FW: PMRE Segment 6 - Bridge 174.3

**80 FOOT THRU GIRDER
BRIDGE 174.3**

**MODIFICATIONS FOR BALLAST DECK
PLAN AND SECTIONS**

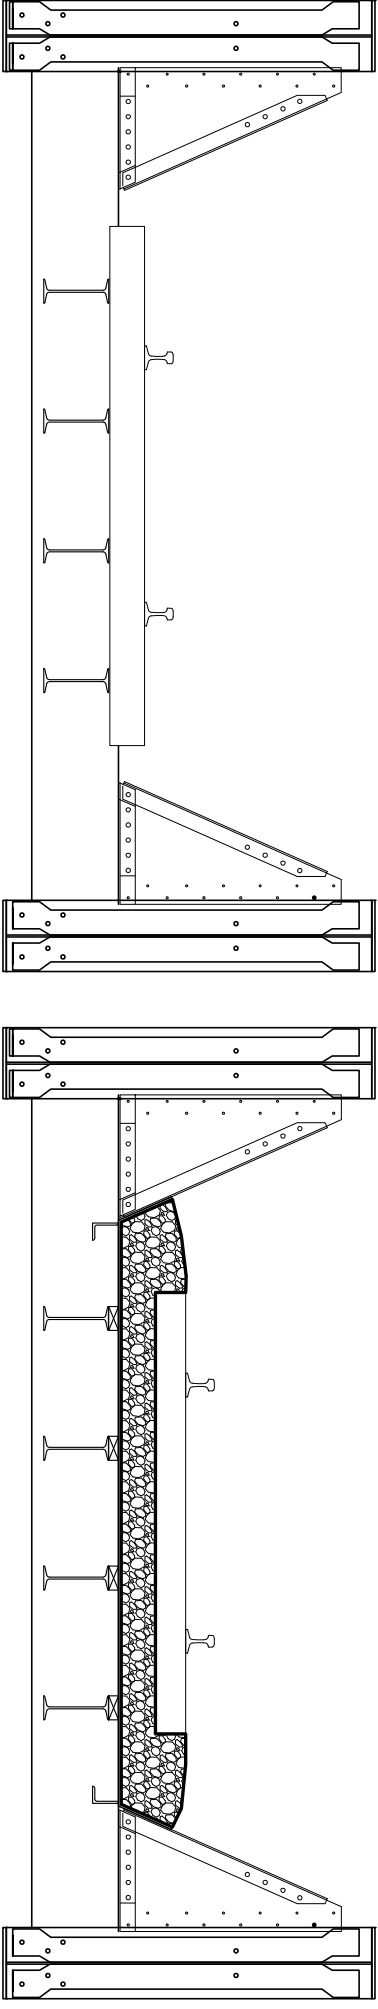
Based on my review of the information you provided regarding the current proposed changes to the bridge, I believe that these changes would have a minor direct effect on the structure in regards to integrity of materials and design. However, I believe that these impacts would have minimal impact on the bridge's eligibility for the National Register. Bridge decks are routinely replaced as needed, and the deck for this bridge was most recently replaced in 1979. Although the deck design would be slightly modified (ballasted deck versus open deck), this change is reversible. While some materials and design elements associated with the deck would be changed (i.e., new steel pan, ties, and ballast), the majority of the materials and design elements (e.g., steel girder, floor beams, stringers, and lateral braces) would not be changed. These changes would not be apparent from most viewpoints. The change in deck design could benefit the bridge by strengthening the structure, which could increase its longevity for continued use by ARRC.

I do not believe these changes would have an adverse effect on Bridge 174.3 (ANC-00085). I agree that additional Section 106 consultation with STB and SHPO is needed regarding these proposed changes.

ARRC recently determined that minor changes are needed to the existing Little Susitna River Railroad Bridge (ANC-00085) at Mile 174.3, which is within Segment 6 of the PMRE. A description of the proposed changes are provided below, and a figure is attached.

ARRC identified a need to strengthen the bridge, which would be accomplished by converting the existing open deck to a ballast deck. Currently, the open deck is fixed in elevation and prevents adding new ballast in the track adjacent to the bridge, resulting in poor track geometry in the bridge approaches. The poor geometry is cumulative with the abrupt change in track support stiffness occurring directly off each end of the open deck bridge. This in turn increases load impact factors experienced by the bridge structure and track components. The proposed replacement of the open deck with a ballasted deck would eliminate the abrupt change in track support stiffness, thereby reducing track maintenance cycles and increasing bridge component life. We have designed the bridge modification so that there would be no change to the steel girder, floor beams, stringers, or lateral braces. The designed ties on the existing deck are set between the floor beams and connected to the stringers. These ties would be removed and replaced with a steel pan with side panels, which would be connected to the stringers. Standard railroad ties and ballast would be placed in the pans. These changes would strengthen the bridge and increase its longevity. Notably, all of these changes are reversible, and the bridge could be converted back to an open deck bridge at any time.
